# Access Compliance Report

## Public Rights-of-Way

Intersection ID: 14312	Main Street: W_TYVOLA_RD	Cross Street: SHADY_LN	Location: E
ADA ID: A78DCF5284FD	Ramp Type: Combination1	Initial Pass/Fail: Fail	Overall Compliance: No
		Severity Score: 22.5

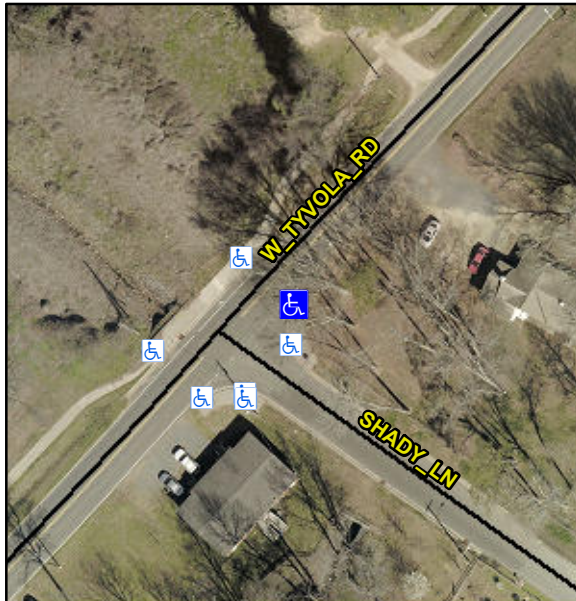
**RT RP < 5%**

**Not Found, R304.5.1, R304.3.2, R304.5.3**

Compliance	Description	Data	Compliance	Description	Data
N/A	Ramp Length LT (in)	68.0	N/A	Ramp Length RT (in)	58.0
Yes	Ramp Width LT (in)	83.0	Yes	Ramp Width RT (in)	83.0
No	Ramp Slope LT (%)	10.4	Yes	Ramp Slope RT (%)	3.0
Yes	Ramp XSlope LT (%)	0.6	No	Ramp XSlope RT (%)	2.1
N/A	Ramp Length (in)	83.0	Yes	Ramp Slope (%)	3.3
No	Ramp Width (in)	37.0	Yes	Ramp XSlope (%)	1.8
N/A	Flare Type LT	N/A	N/A	Flare Type RT	N/A
N/A	Flare Slope LT (%)	N/A	N/A	Flare Slope RT (%)	N/A
N/A	Flare Traversable LT?	N/A	N/A	Flare Traversable RT?	N/A
N/A	Landing Length (in)	N/A	N/A	DWS Provided?	N/A
N/A	Landing Width (in)	N/A	N/A	DWS Contrast?	N/A
N/A	Landing Slope (%)	N/A	N/A	DWS Length (in)	N/A
N/A	Landing X Slope (%)	N/A	N/A	DWS Full Width?	N/A
N/A	Landing Curb? (Y/N)	N/A	N/A	DWS Offset (in)	N/A
N/A	Shared Landing?	N/A			
N/A	Gutter Ponding?	N/A	N/A	Gutter Slope (%)	N/A
N/A	Gutter Lip Ht (in)	N/A	N/A	Gutter X Slope (%)	N/A
N/A	Painted X Walk1?	No	N/A	Painted X Walk2?	N/A

**Remove & Replace Entire Ramp.**
